INTEROFFICE MEMO

SUBJECT: Moore-Griffith Blow Off Connection to Storm Drain (PUD Dwg. No. D5-704164)

TRANSMITTED: Moore-Griffith Blowoff Modification Plan

8" BLOWOFF PIPING

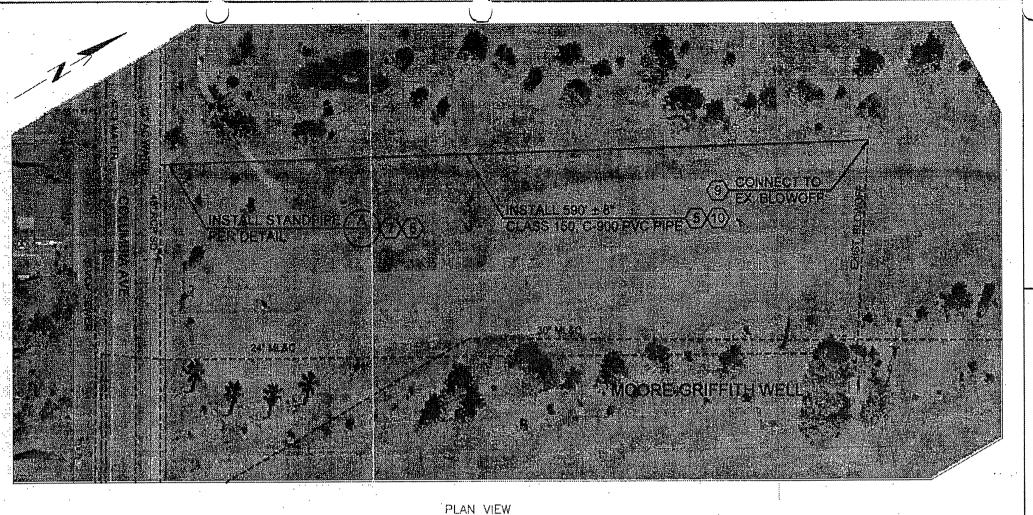
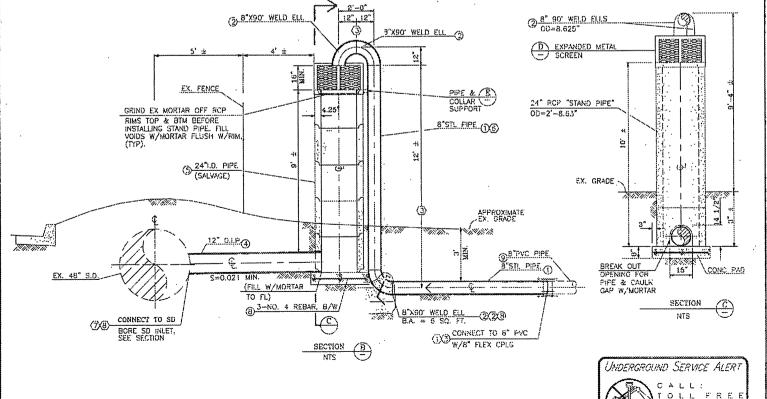
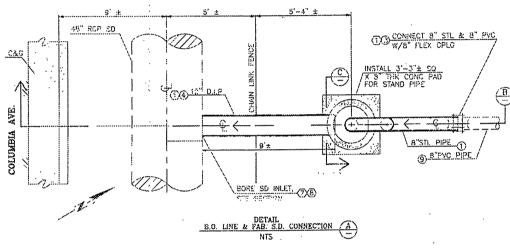
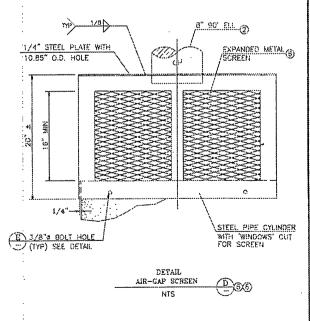
Your staff has requested an encroachment permit to connect a blow off line from the Moore-Griffith well to the 48-inch storm drain in Columbia Avenue adjacent to the Riverside Golf Club. This connection is proposed to be located at approximate station 18+20 (D-548). An encroachment permit is not necessary, however the Public Utilities Department must meet the following conditions in order for the connection to be made.

- In the future, the blow off must be disconnected from the storm drain system if the constituents in the discharge water exceed standards established by regulatory agencies. The time frame for disconnecting the blow off will be mutually agreed upon by both departments.

- 48 hours prior to discharging the blow off to the storm drain system the Public Utilities Department must notify the Public Works Department, Street Maintenance Division, 351-6127. This notification must include the date, time, and duration the discharge is to occur.

- The blow off may not be discharged to the storm drain system during any storm event.
- The Public Utilities Department is responsible for the maintenance of the blow off and it's connection to the storm drain system. Be aware that the blow off connection is below the 10-year hydraulic grade line of the storm drain system. The Public Works Department is not responsible for the cleaning of any silts and debris that enter the blow off system due to this design.

• If the blow off system is abandoned the Public Utilities Department must remove the connection to the storm drain system and repair the storm drain pipe to Public Works Department specifications.
